~~FINAL~~
DRAINAGE LETTER

PONDEROSA PINE ESTATES
A REPLAT OF LOTS 1 AND 2, MORGAN SUBDIVISION NO. 1
18810 and 18820 CLOVEN HOOF DRIVE

VR2324

December 7, 2023

DRAINAGE PLAN

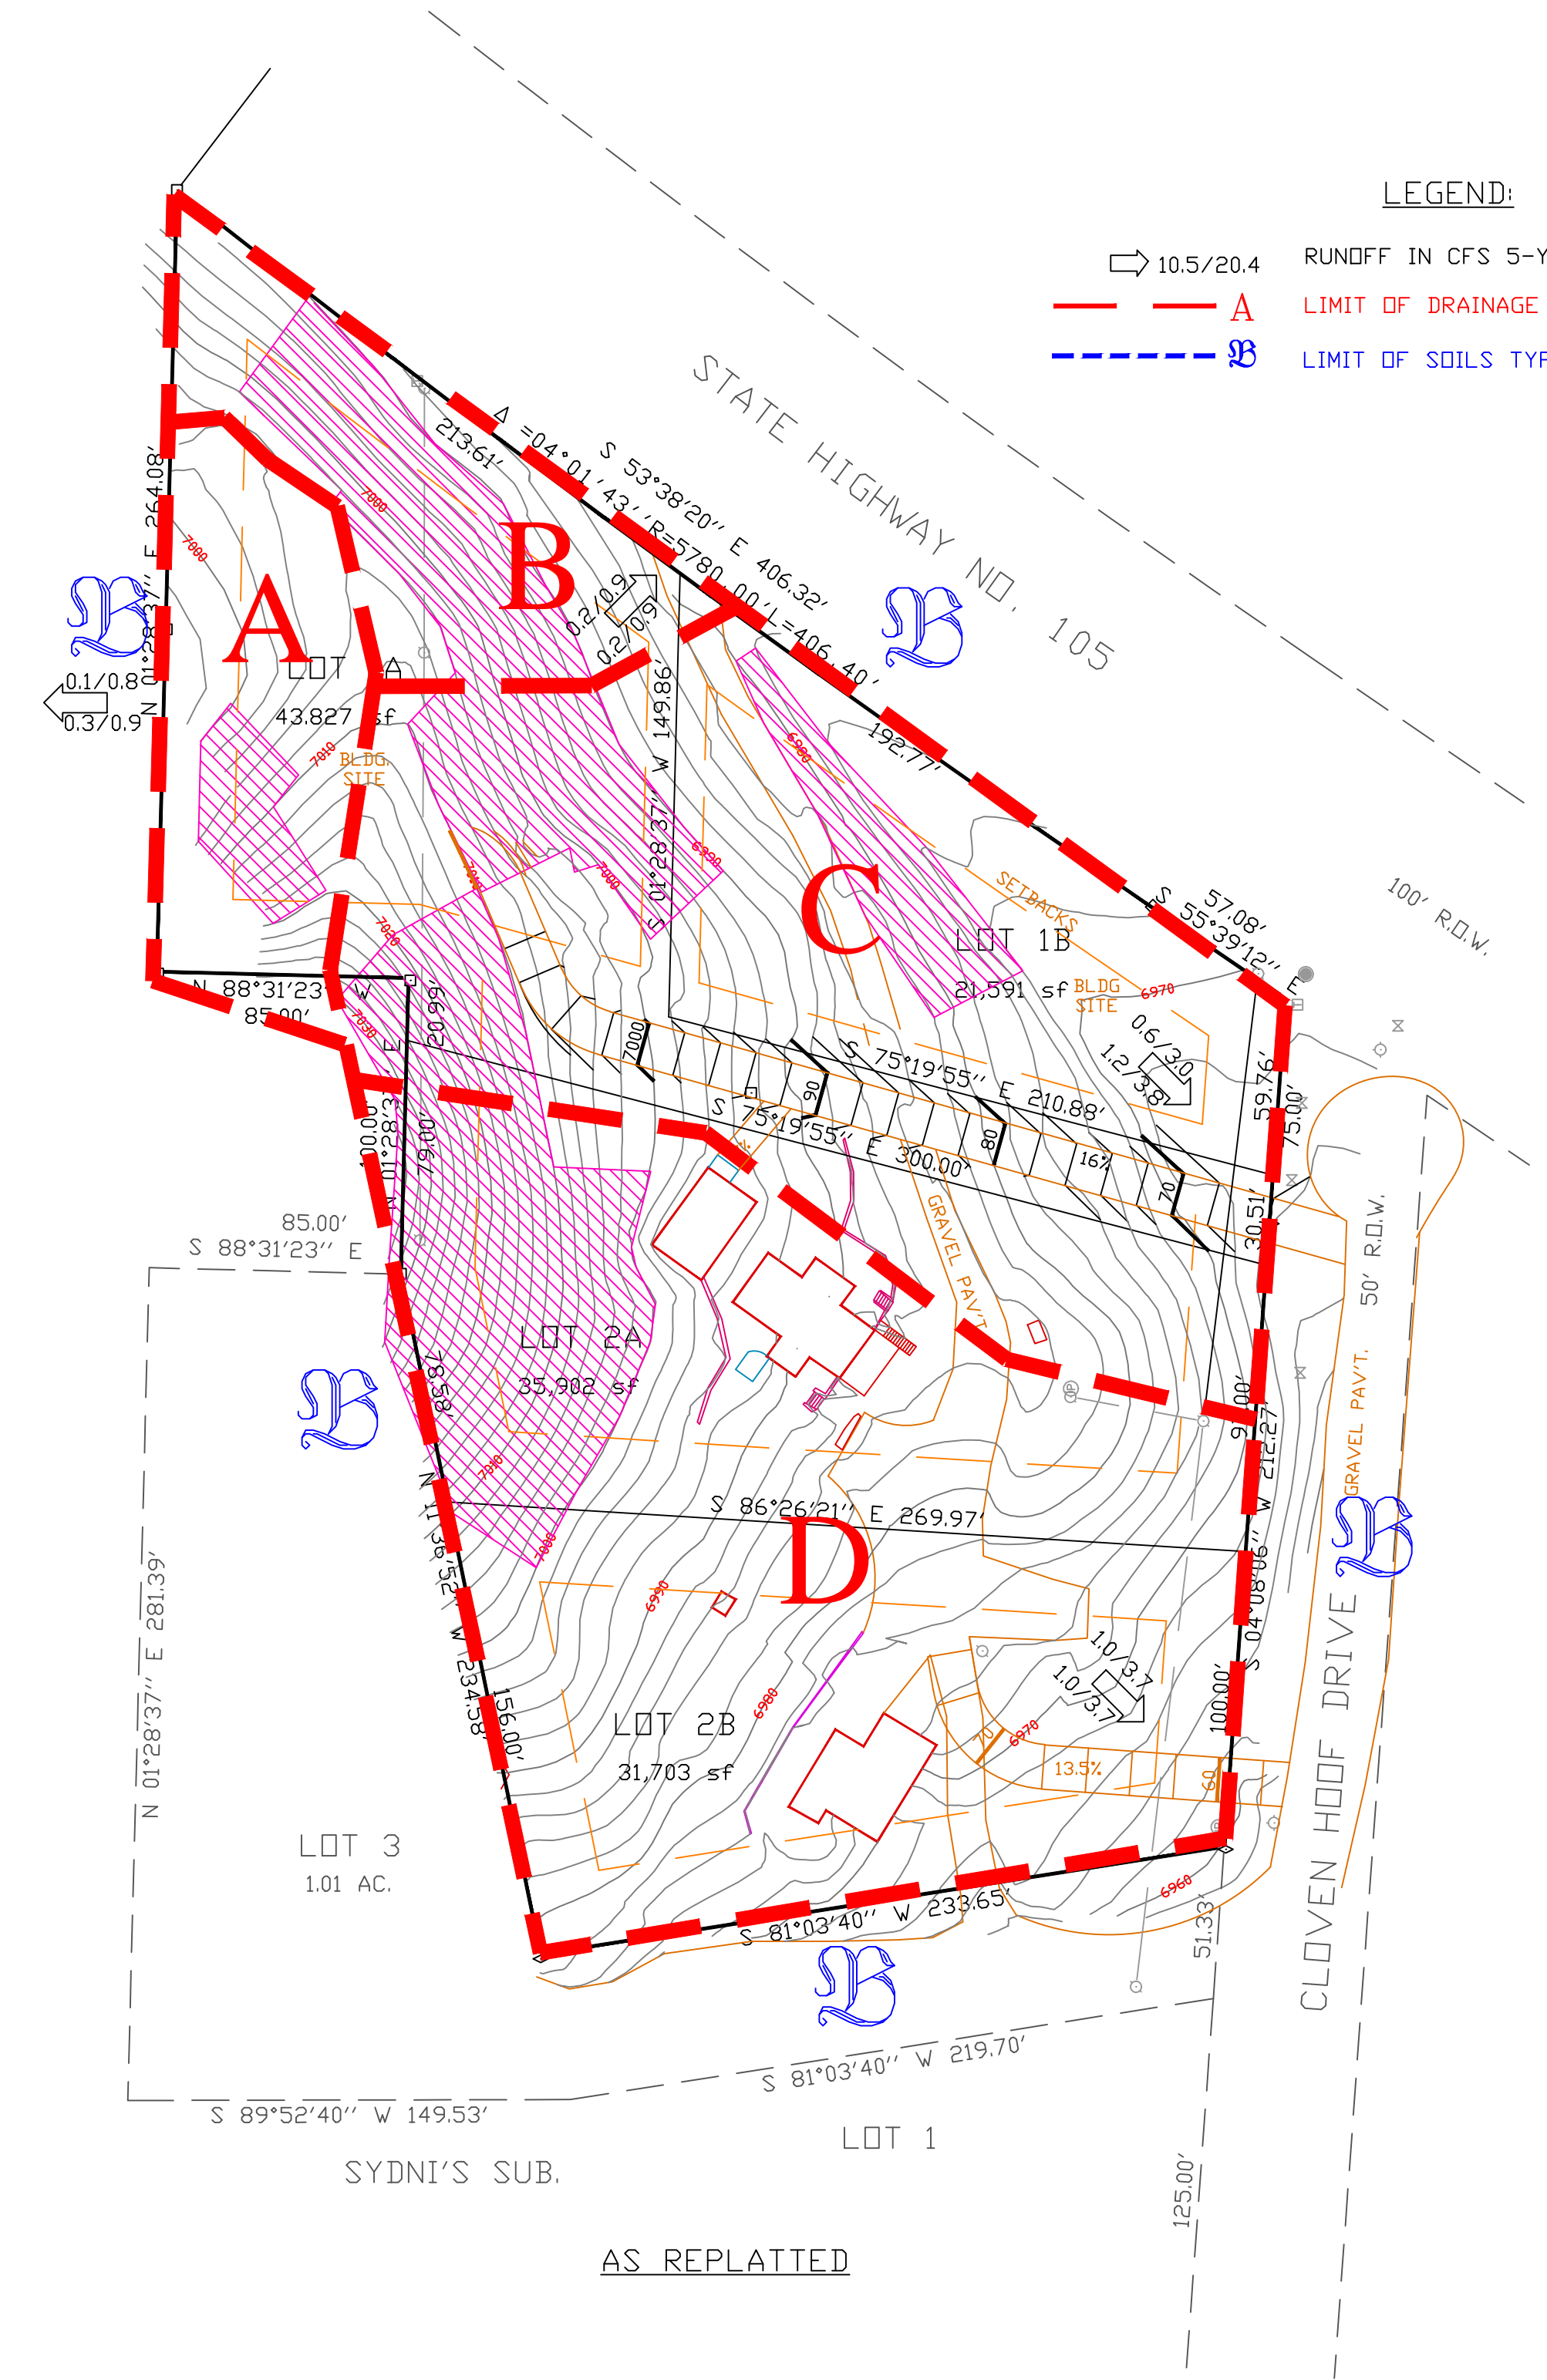
Please label adjacent property as platted with name and filing.
